Docket Item # 10
BAR CASE # 2009-0148

BAR Meeting
July 29, 2009

ISSUE: Demolition

Figure 2: Proposed Rear Façade

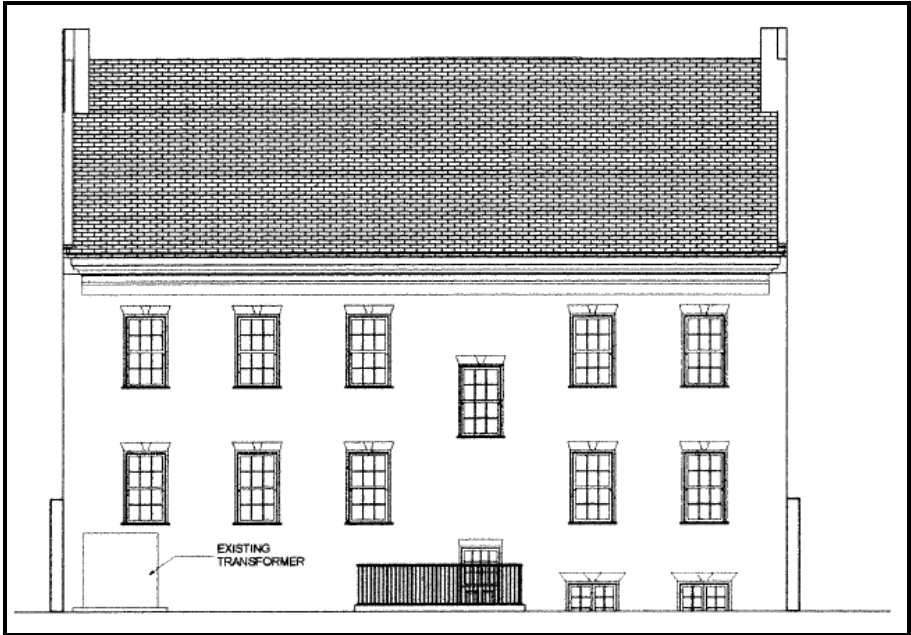
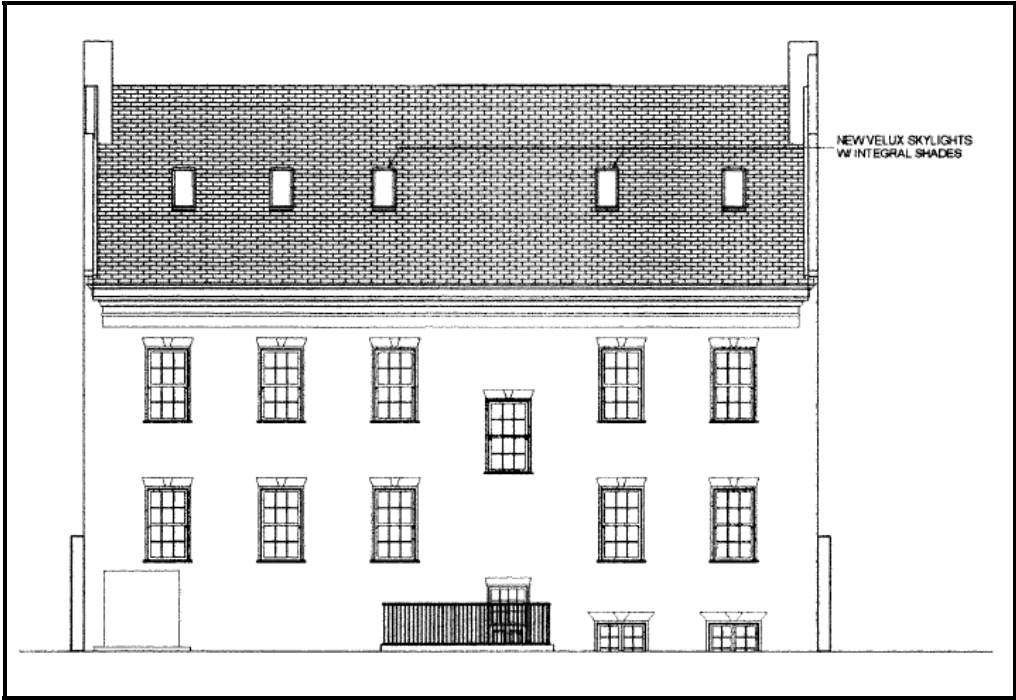
The applicant is requesting approval of a Permit to Demolish in order to install five, Velux skylights on the rear (west) roof slope of the two-story office building located at 424 North Washington Street. The area of demolition is approximately a total of 36.4 square feet (penetration into the roof installation of five skylights measuring 20 inches wide x 50 inches long).

In the opinion of Staff, none of the criteria are met. The portion which will be impacted by the demolition dates from the late-20th century and is located on a less prominent façade of the building – the rear elevation, thus maintaining the traditional building form and the integrity of Washington Street.

Staff recommends approval of the Permit to Demolish.
